Village of Arlington Heights
Plat and Subdivision Committee
Community Room, 3rd Floor
Arlington Heights Village Hall
33 S. Arlington Heights Road
Arlington Heights, IL 60005
August 13, 2014
6:30 PM

Item: Miner Street Development - Vacant Lot, 13 E. Miner St. - T1391

STAFF DEVELOPMENT COMMITTEE REPORT

Item: 909 W. Campbell Street Subdivision - T1460

SITE PLAN

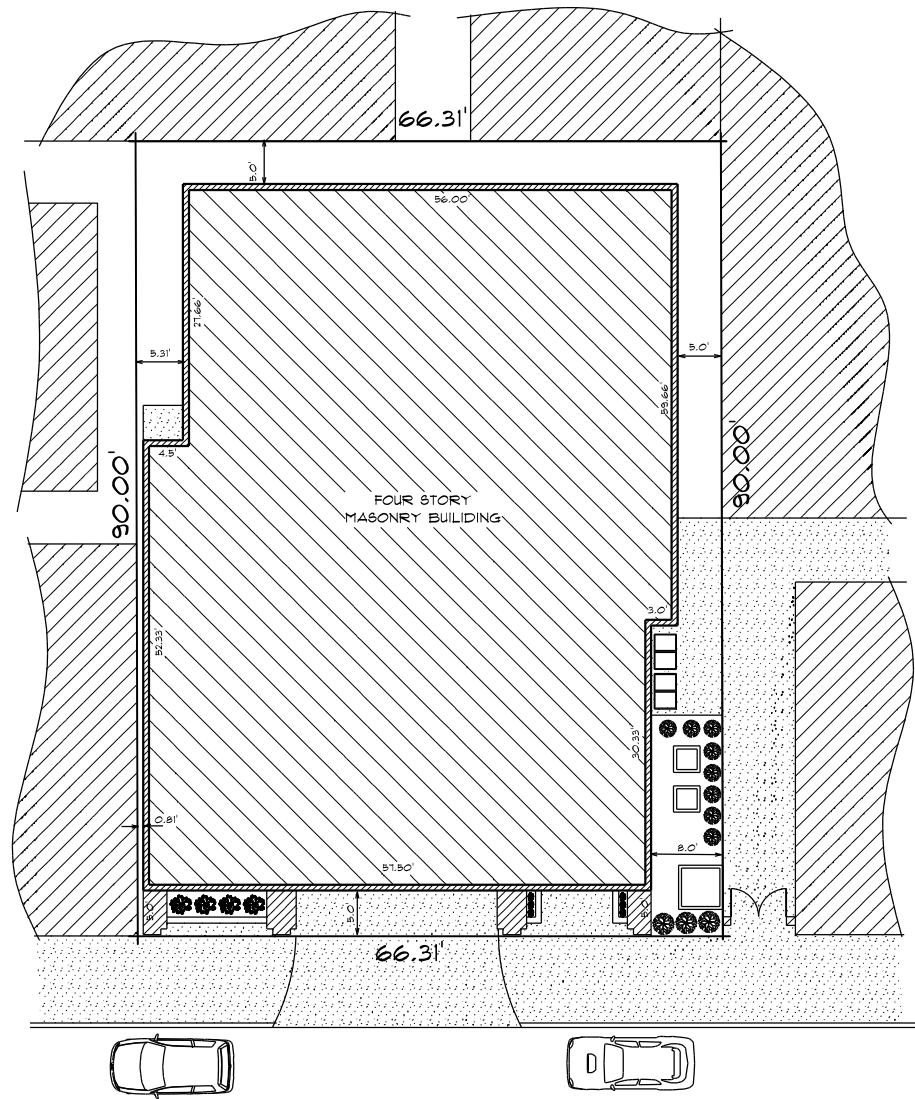
The plans include a 5.81 foot west yard setback and 0 feet east yard setback. While a reduction to the aforementioned setback is appropriate given the urban setting in which the proposal is being located, the exact amount will need to be further evaluated in conjunction with building/fire separation requirements, access to the rear area and location/relocation of existing utilities. In addition a written justification based upon the following criteria shall be required:

Regarding the rear (south) yard setback, all Downtown developments are required to provide for residential uses located above the first floor, a yard not less than 30 feet. Pursuant to the concept site plan, said development has a 5 foot setback from the south property line, thereby resulting in the following variation:

The Petitioner must provide a written justification based upon the above mentioned hardship criteria as well as demonstrate that 5 feet is sufficient to accommodate servicing functions, exiting requirements, utilities and building and fire separation requirements.

- **Variation from Section 28-11.2-8 from the required two-way drive aisle width of 24 feet to allow 18 feet;**
Instead of the required 24 feet, an 18 foot drive aisle is proposed for portion of the interior parking garage. The Petitioner must provide a written justification based upon the above mentioned hardship criteria.
- **Variation from Section 28-11.7, Schedule of Loading Requirements, to waive the required loading berth for the development.**

5. The proposed development concept provides 10 parking spaces, thus requiring a variation. Since no accessible parking spaces are illustrated on the plan, one accessible parking space must be provided. Therefore, it appears that the total parking spaces provided on site will be reduced to 9 spaces. The remainder of the parking spaces will have to be provided for within the Village's parking garage. However if commercial space is provided, then all parking will need to be accommodated in the Village's North garage subject to reallocation of spaces in that garage.

FRONT ELEVATION

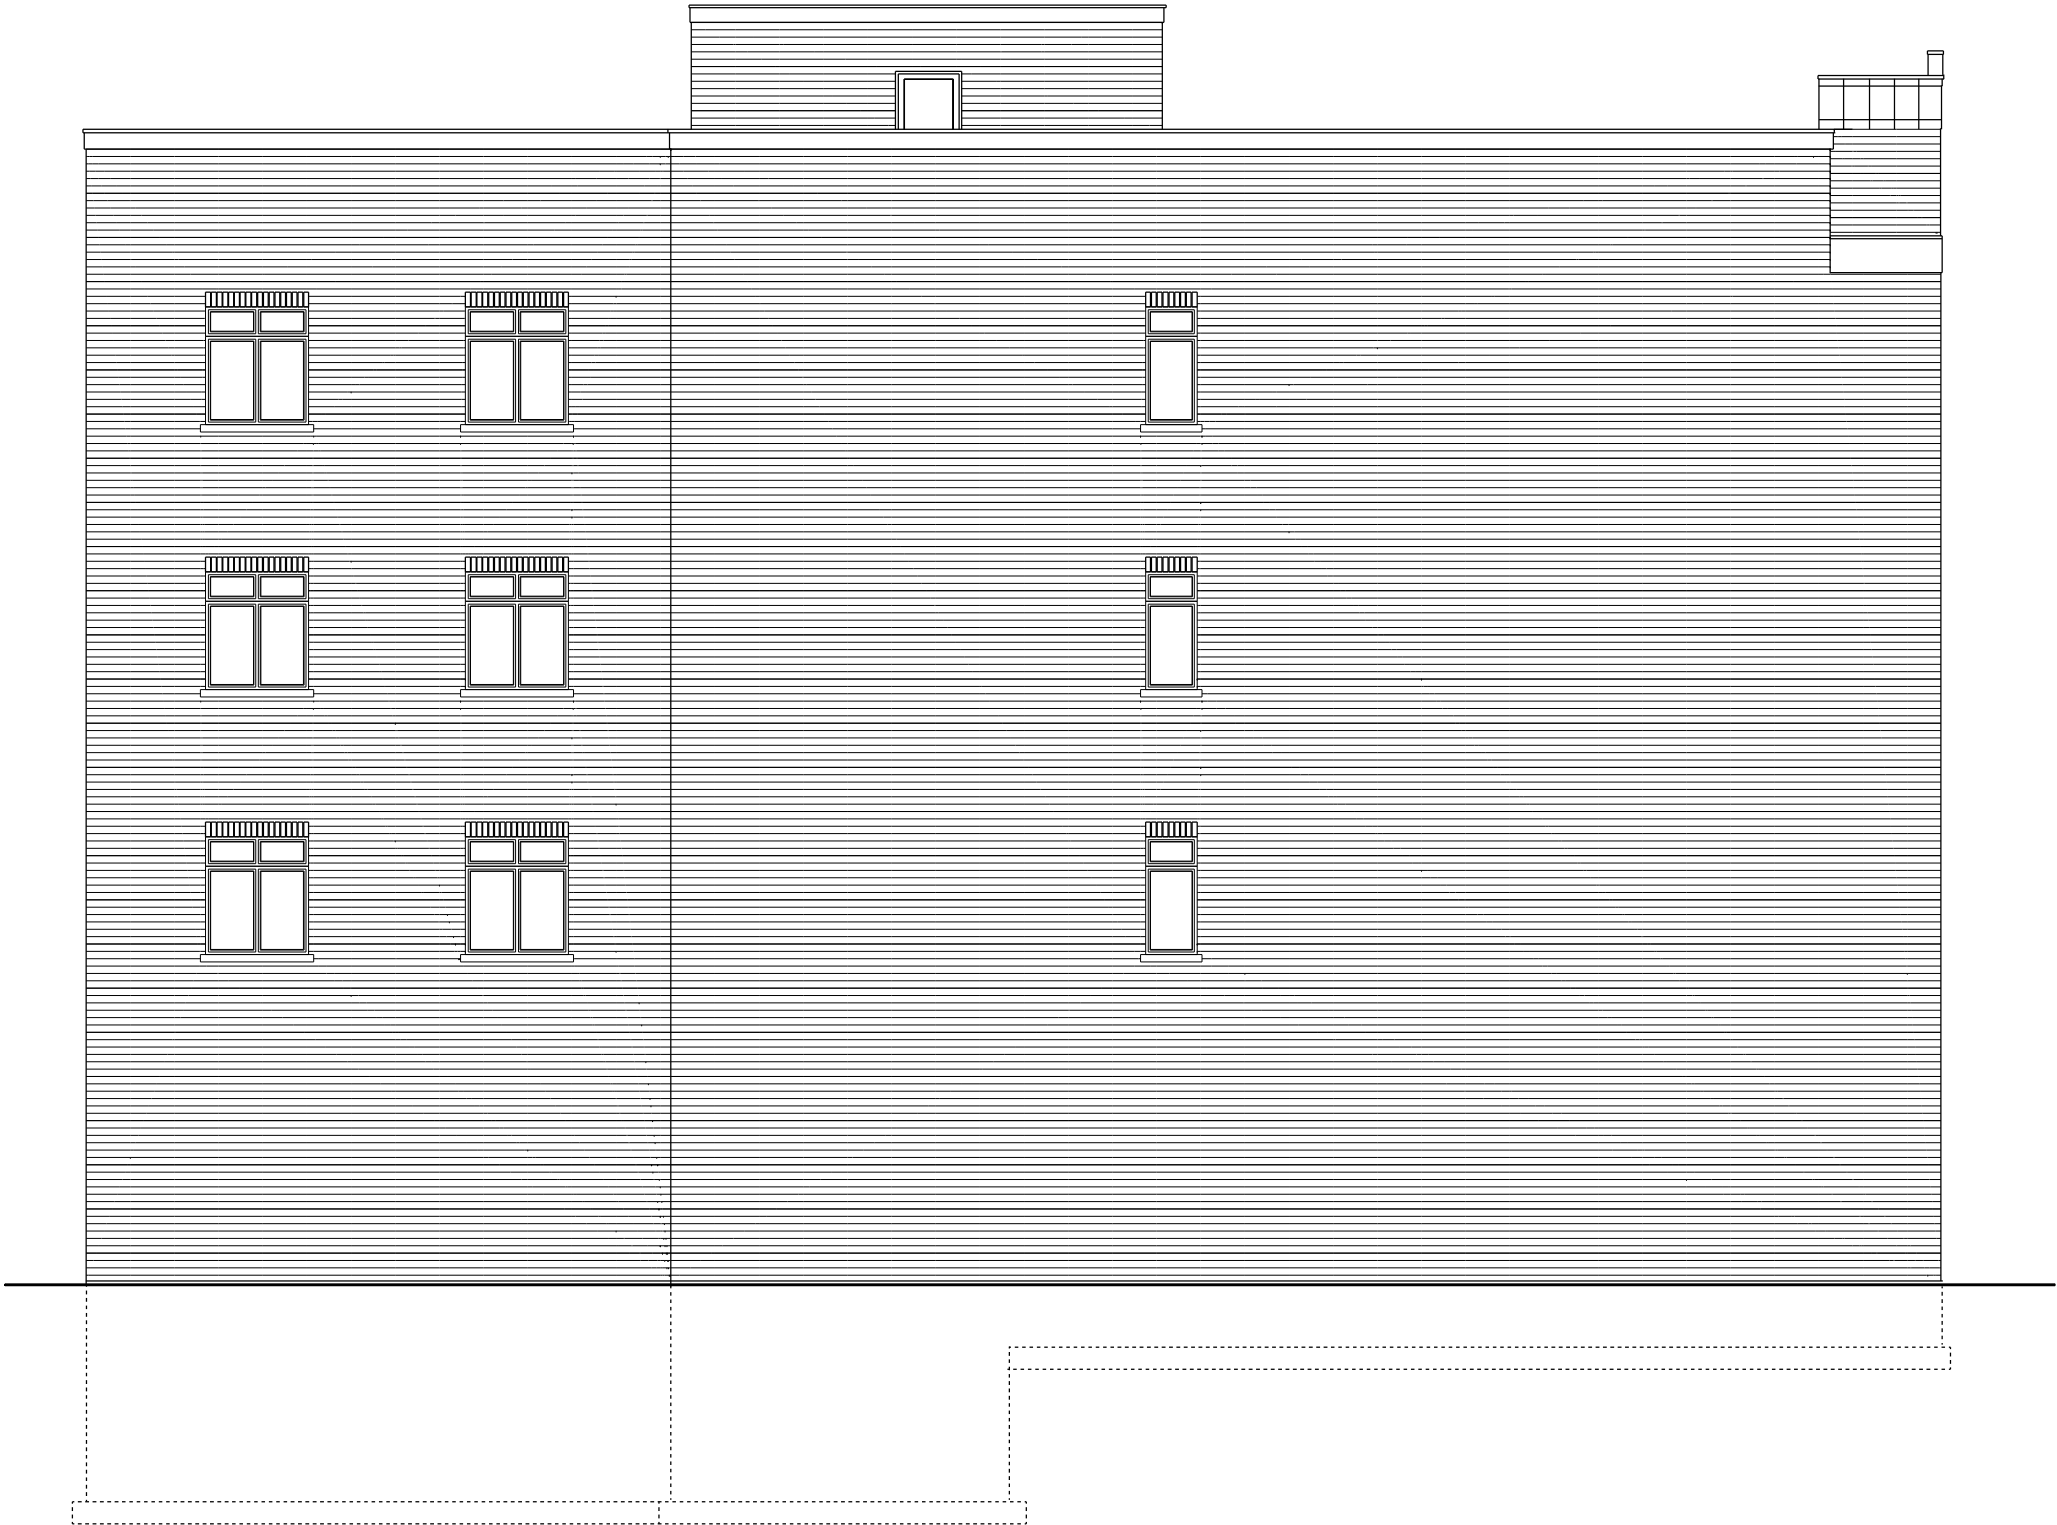
The B-5 district permits a height of 90 feet with a maximum height limit of 140 feet if a development complies with the Downtown height bonus standards. The maximum building height is exclusive of elevator penthouses, stair heads and other mechanical equipment facilities. Based on the plans submitted, the proposed four-story building is 48 feet tall to the roof deck line and the parapet extends approximately another 6.5 feet to 54.5 feet. However, the context of the block should be taken into consideration to ensure that the proposed development is in harmony with other development on the block, thus the height should be evaluated in context as an infill development. Staff has concerns with the height as being out of context with the surrounding block.
